Project: **RFQ-1202-2025**
Project Name: University Hall HVAC Upgrade
Project Number: 20020136
Date: August 27, 2025
Page: 1

Amendment No.1 – MCW Addendum No. 01

Title: Mech/Elec Addendum 01
Reason for Change: Revisions to capture addendum questions and permit comments

E2-02

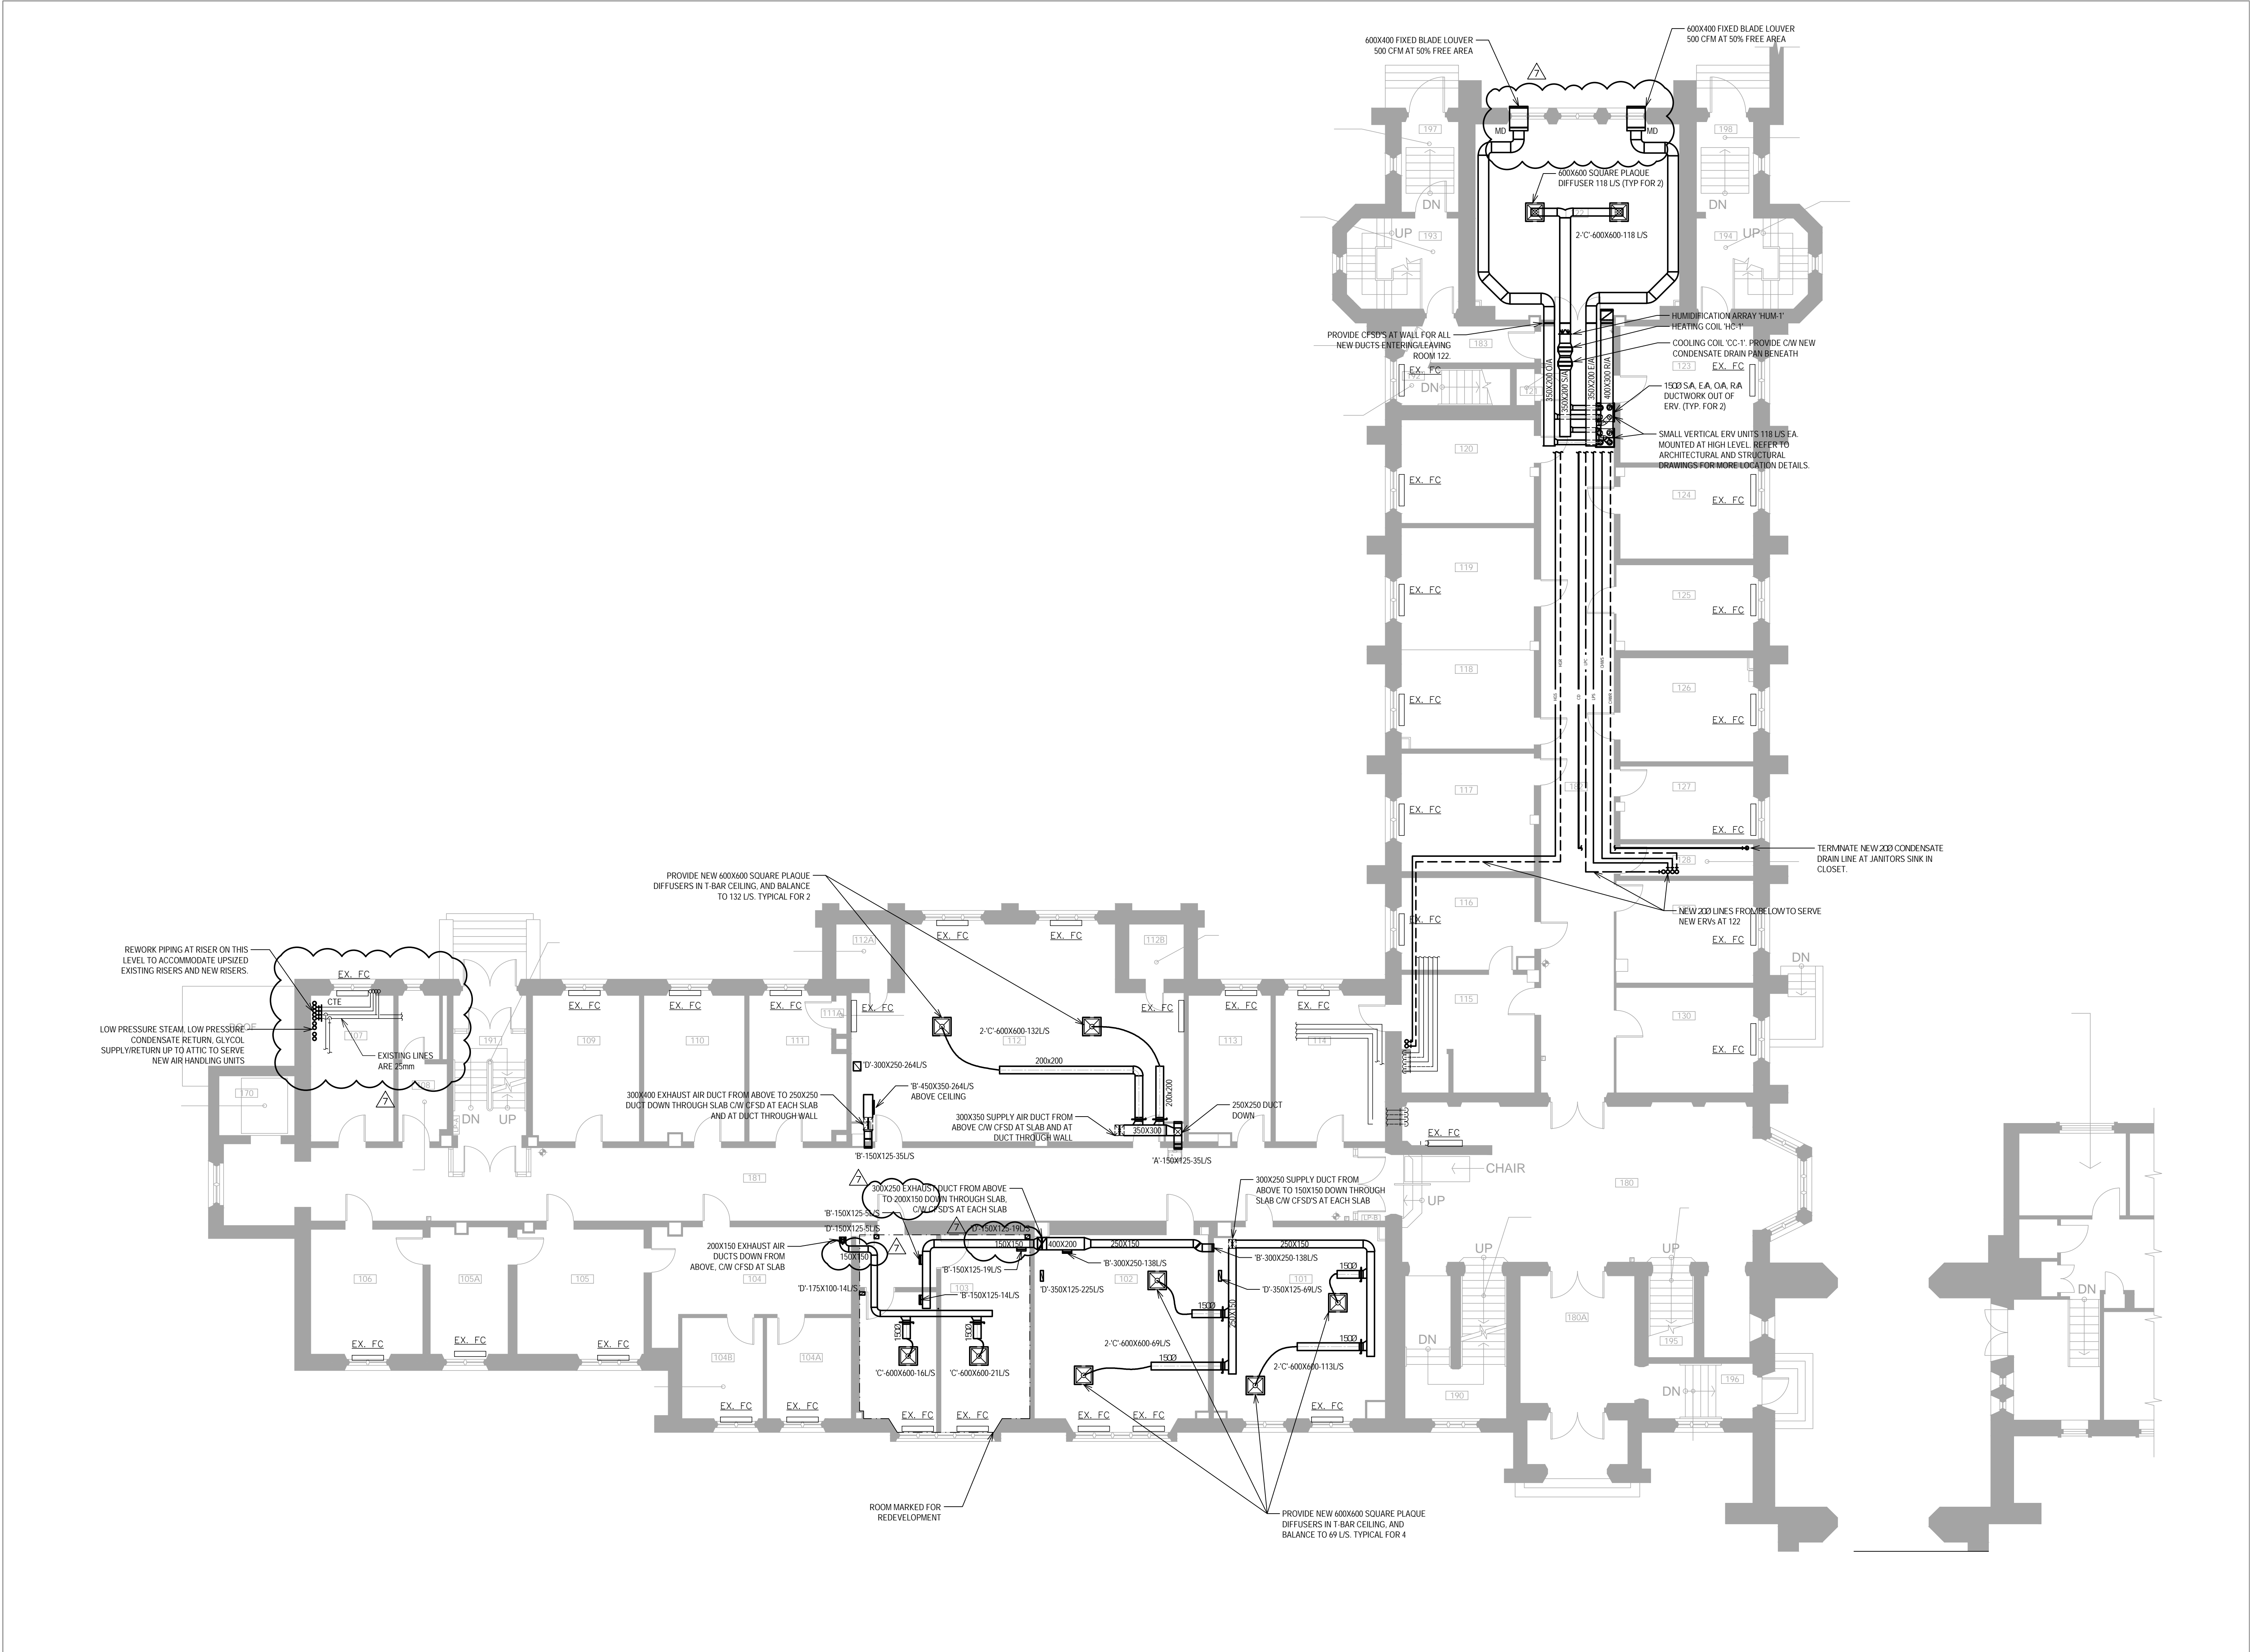
Drawing #	Revisions
E2-01	<ul style="list-style-type: none">Added note. 5.
E2-02	<ul style="list-style-type: none">Added note. 5.
E2-03	<ul style="list-style-type: none">Added note. 5.
E2-04	<ul style="list-style-type: none">Added note. 5.
E2-05	<ul style="list-style-type: none">Added note. 2 & 3.Added scope for combination fire smoke dampers.

M2.1

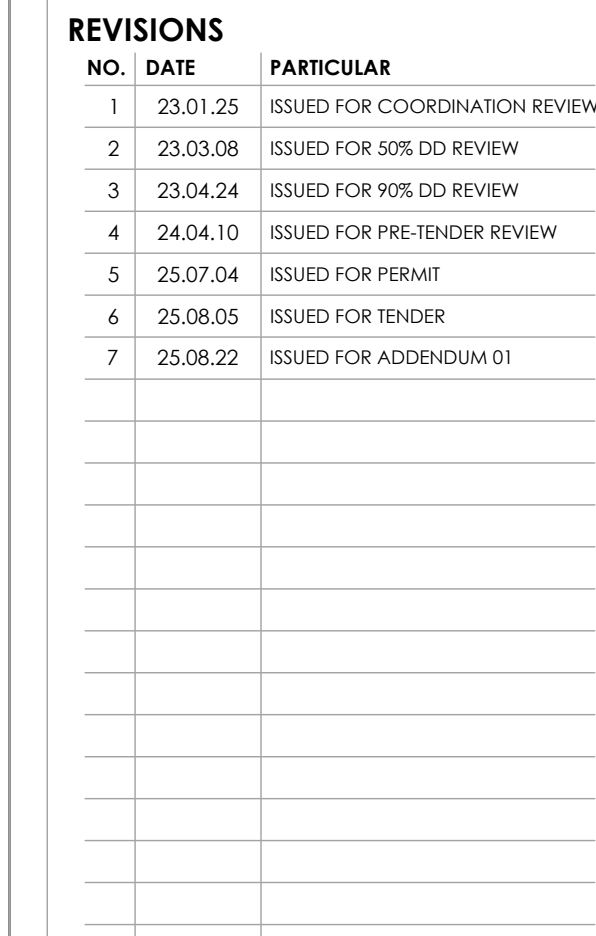
Drawing #	Revisions
M0.1	<ul style="list-style-type: none"> Revised energy/heat recovery ventilator/wheel schedule with details on sound power levels, as well as additional details on unit construction. Revised air handling unit schedule with additional details on construction and installation.
M0.3	<ul style="list-style-type: none"> Revised ERV-1 riser diagram and match with revisions to floor plan.
M1.0	<ul style="list-style-type: none"> Added existing pipe sizes.
M1.1	<ul style="list-style-type: none"> Added existing pipe sizes.
M1.2	<ul style="list-style-type: none"> Added existing pipe sizes.
M1.3	<ul style="list-style-type: none"> Added existing pipe sizes.
M2.0	<ul style="list-style-type: none"> Revised exhaust and supply duct sizes. Added existing pipe sizes.
M2.1	<ul style="list-style-type: none"> Revised exhaust and supply duct sizes. Added existing pipe sizes. Added motorized dampers to the F/A and E/A ducts within room 122
